Hawke's Bay Regional Council

Responses to Questions from the Hawke's Bay Independent Flood Review

Figure 6.3 – Waipawa River gravel availability at Waipawa pre-cyclone vs post-cyclone

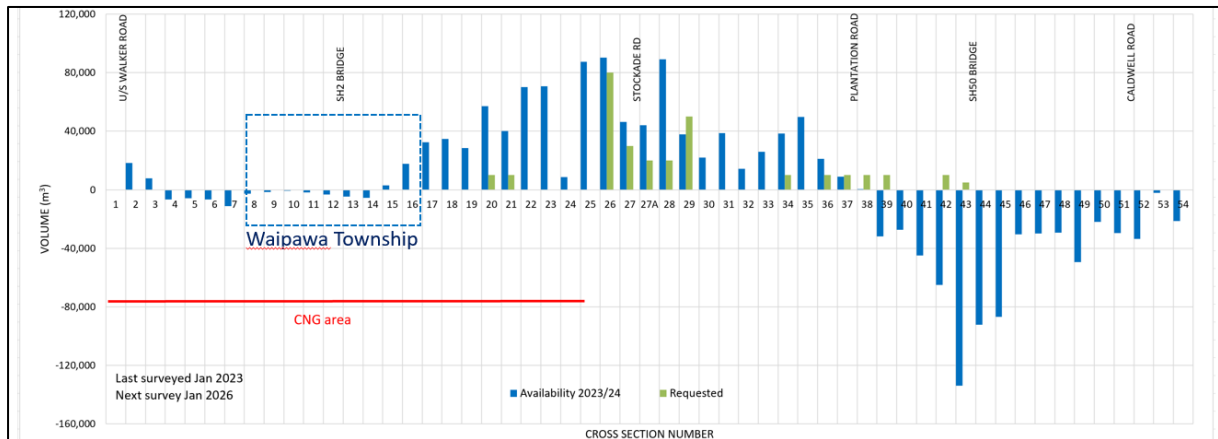
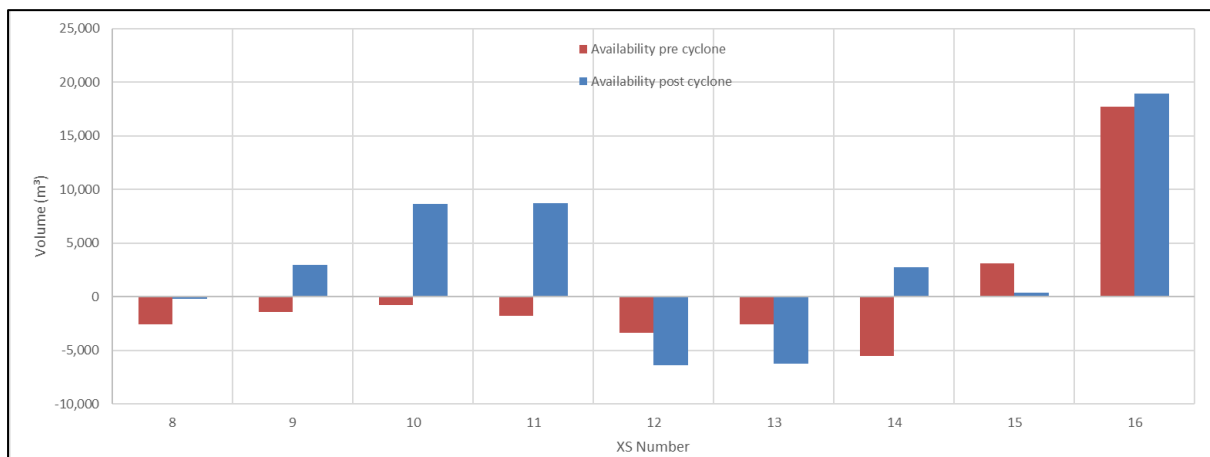
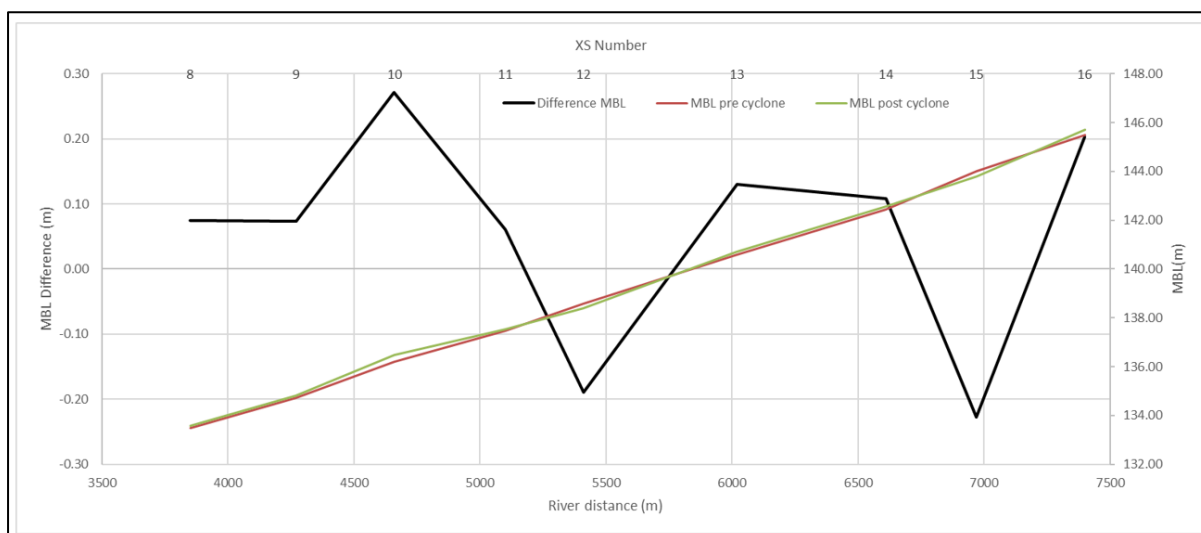
6. Please comment and provide all relevant data on the extent to which this excess gravel build-up in the Waipawa River contributed to the flooding that occurred through Waipawa during Cyclone Gabrielle.

Based on our observations and analysis, the increase in gravel in the rivers was generally not in the locations where stopbank overflows or breaches occurred, such that a correlation could be drawn between increased gravel levels and the key mechanisms causing flooding (i.e. stop bank overtopping and breaching) during Cyclone Gabrielle.

HBRC staff presented to a Council gravel workshop on 7 Jun 2023 the following data on Waipawa River. Staff concluded that there was not a significant volume above grade from the section adjacent to the Waipawa township (where flooding occurred), as demonstrated in Figures 6.2 below to 6.4 below.

Note: While this graph shows the total movement in gravel (in m3) upstream and down stream of the SH2 bridge (Bench mark 12) - the total change in grade was 150mm.

It should be noted that, while in some sections gravel is above the current grade line, in other sections it is below the grade line.

It should also be noted, as was mentioned above, that any areas of gravel aggradation are many kilometres from the Waipawa township, where overtopping of stopbanks occurred. The width of Waipawa river diminishes significantly, from an average width of 160m to around 100m, just downstream of the township. This is more likely to have been a factor in containment of flood flows.

Figure 17.1 – 1:100-year flood extent in vicinity of Waiohiki

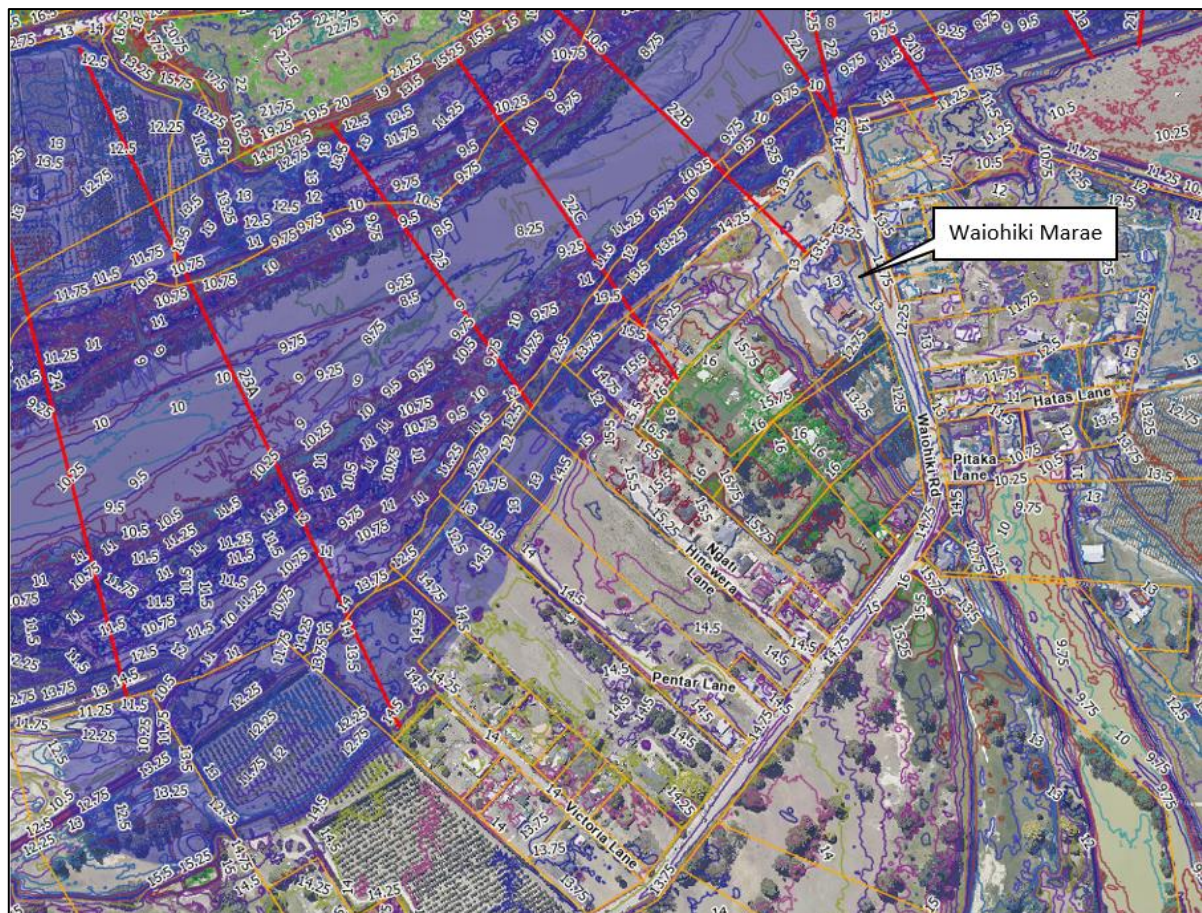
17. Please confirm the factual situation as to the extent of flood protection provided in this area.

18. Subject to the response to 17. above, would the flooding experienced around the Waiohiki marae have been any different if flood protection up to the 1% AEP protection referenced in the HP-AMP had been in place prior to Cyclone Gabrielle?

This portion of the scheme was constructed in 1989-92, and the design flood levels indicate that at all cross-section locations and all interpolated locations in this area, the 100-year flood level was below the high ground level (i.e. this location was adequately protected up to the 1% AEP event). This is shown in the following figure 17.1. The blue shaded area shows the extent of the 100-year flood level. Contours shown use NZVD16 datum.

This area was subject to flooding during Cyclone Gabrielle. Two main causes for this flooding were that the flooding significantly exceeded the 1:100-year level and that debris at the Redclyffe Bridge created a damming effect, forcing water into the referenced area.

As illustrated in Figure 17.1 above, this area was already protected to the 1%AEP. Based on the original analysis for the stopbank design, the referenced area was above the 1%AEP flood levels.

Figure 19.1 – Schematic of proposed works at Waiohiki

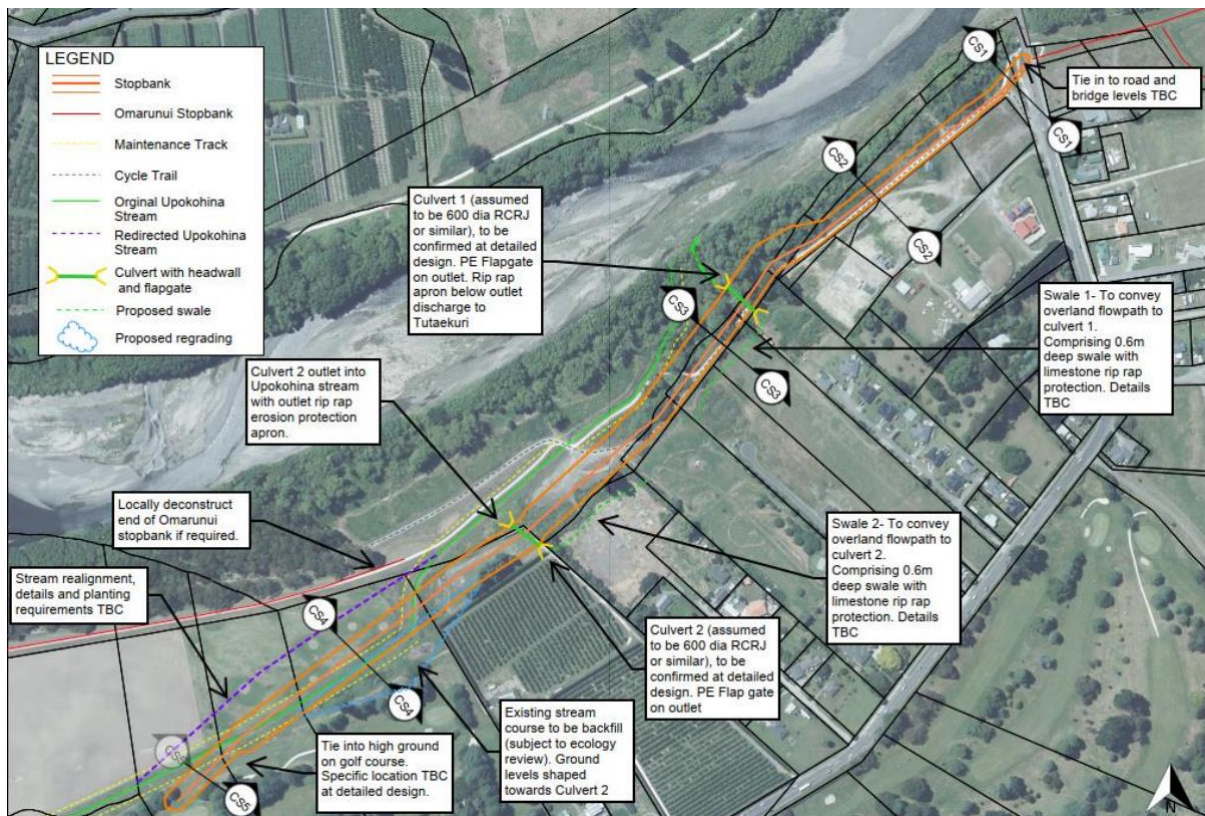
19. Subject to the response to 17. above, what plans are in place for addressing the gap in the stopbanks at Waiohiki?

Notwithstanding the fact that the referenced area is above the modelled 1:100-year flood levels, Cyclone Gabrielle demonstrated that this area is a relative weak point in the Heretaunga Plains Flood Control Scheme. This is due to its proximity to the bridge and because the high ground, while above the 1:100-year flood levels, appears to provide less freeboard above those levels than areas protected by stop banking. HBRC has therefore identified the need for better resilience at this location.

Accordingly, HBRC’s negotiated funding agreement with the Crown for a programme of flood resilience works across the Hawke’s Bay includes a co-funded sum of \$10m, which is dedicated to works at Waiohiki.

Planned works at Waiohiki include a new stop bank from Redclyffe Bridge to the rear of Napier Golf Course and realignment of Upokohino Stream to accommodate the new stopbank. A schematic of the proposed works is provided at Figure 19.1 below. This project is presently in planning phase with site investigations complete and preliminary design underway. We anticipate that this project will benefit from the streamlined consenting pathway presented by the proposed Order in Council for Hawke’s Bay Flood Works under the Severe Weather Emergency Recovery Legislation Act 2023.

Figure 21.1 - Comparison of flood frequency curves

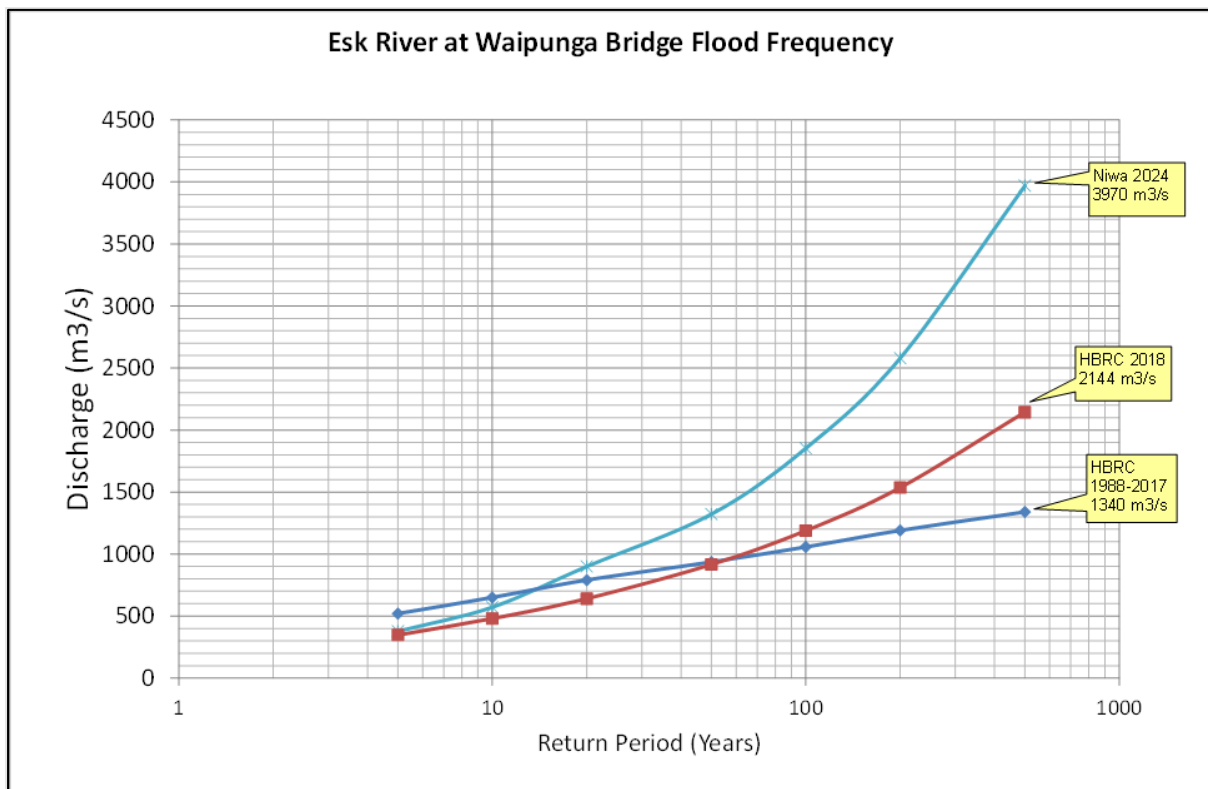
21. Please provide Council’s assessment of why the Whirinaki Drainage Scheme failed below its agreed level of service.

Our assessment, based on the revised NIWA data, is that the flooding at this location exceeded the level of service of this scheme

The analysis in the Esk Asset Management Plan was derived in 2013 (prior to 2018 and 2023 events) and showed the 500-year return period using a Gumbel Distribution for the Extreme Value Analysis was determined to be 1,340 m³/s. The estimated peak flow at Waipunga Bridge during Cyclone Gabrielle was 2,175m³/s. Note this value was estimated from peak levels during the event and includes silt and debris.

The current NIWA analysis presents an update using the additional data from 2013 to 2023, which include the 2018 and 2023 events, both extreme events. This new analysis updated the Extreme Value Analysis with new data to now show the 500-year event is considered to be 3970 m³/s using a Generalised Extreme Value distribution (i.e. a different distribution than that which was used in 2013 and prior).

However, we note that there is a very large margin of error on this present analysis from NIWA. We also note the significant upward curvature of NIWA’s estimated flood frequency curve (as demonstrated in figure 21.1 below). We consider the present estimate in the NIWA report requires additional analysis before a direct comparison to the agreed level of service with this drainage scheme can be drawn. That work will be undertaken as part of the planned resilience works for the Whirinaki Drainage Scheme.

Figure 35.1 – Example Wairoa Flood Maps

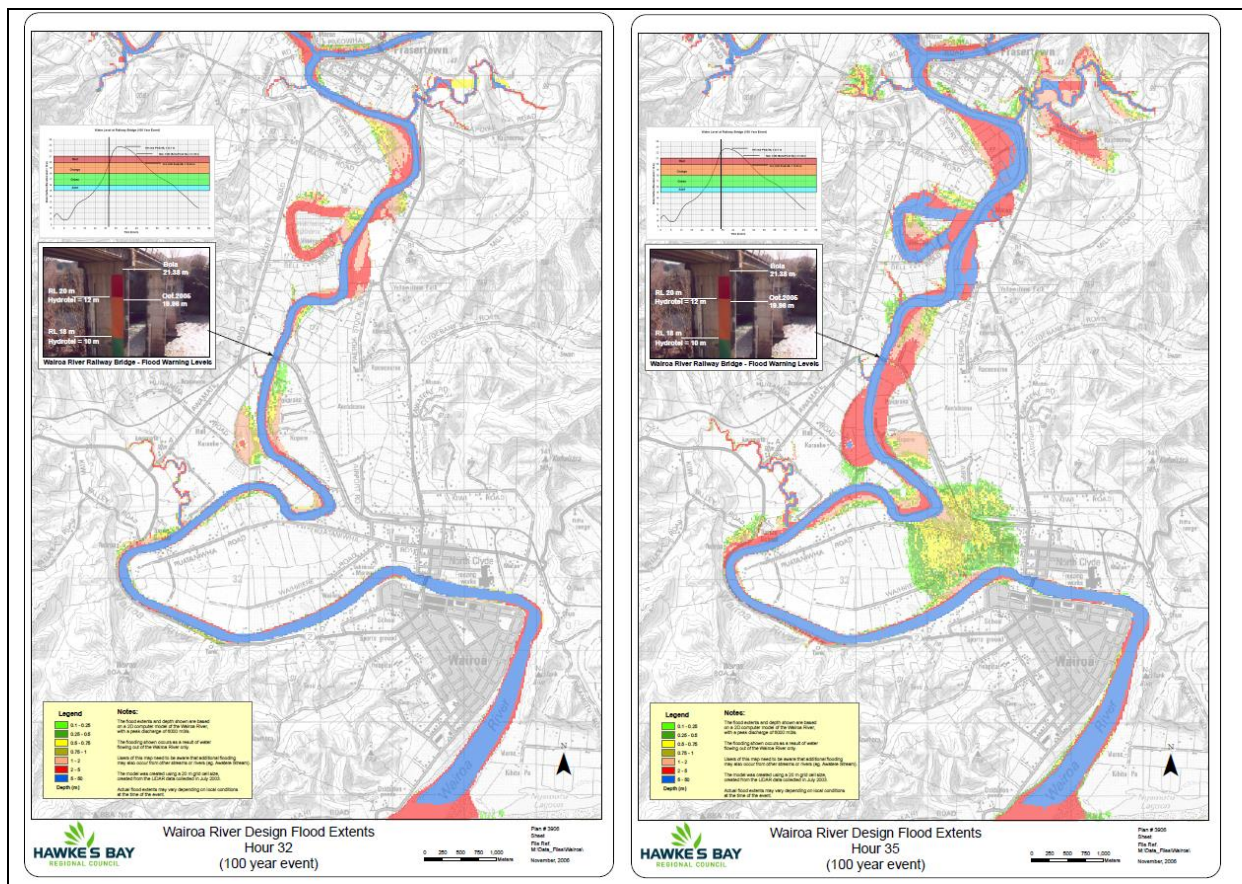
It is noted that the Council's Flood Response Manual (2015) has no information on evacuation trigger levels for any of the rivers within the Region. From reviewing the timeline and communications logs evacuation warnings appeared to be fairly ad-hoc during Cyclone Gabrielle.

35. Please provide details of what evacuation trigger levels were used to inform and advise Civil Defence on evacuation requirements during Cyclone Gabrielle and what planning and analysis were used as the basis for this information.

For Wairoa, HBRC had previously produced a series of flood maps which provide the details relating to the water level recorder at the Railway Bridge in relation to the flood extents that may occur in North Clyde, i.e. trigger levels that would indicate the need for evacuation. Each map contains a hydrograph with a line indicating the current state of the water level at the Railway Bridge, as well as the modelled flood extents which shows the depth of flooding according to the legend. Two examples are shown at Figure 35.1 below, with the left-hand image showing no flooding occurring in North Clyde when the level at the Railway Bridge has just reached the RED warning level. The right-hand image shows flood extents associated with the level at the Railway Bridge above the RED level.
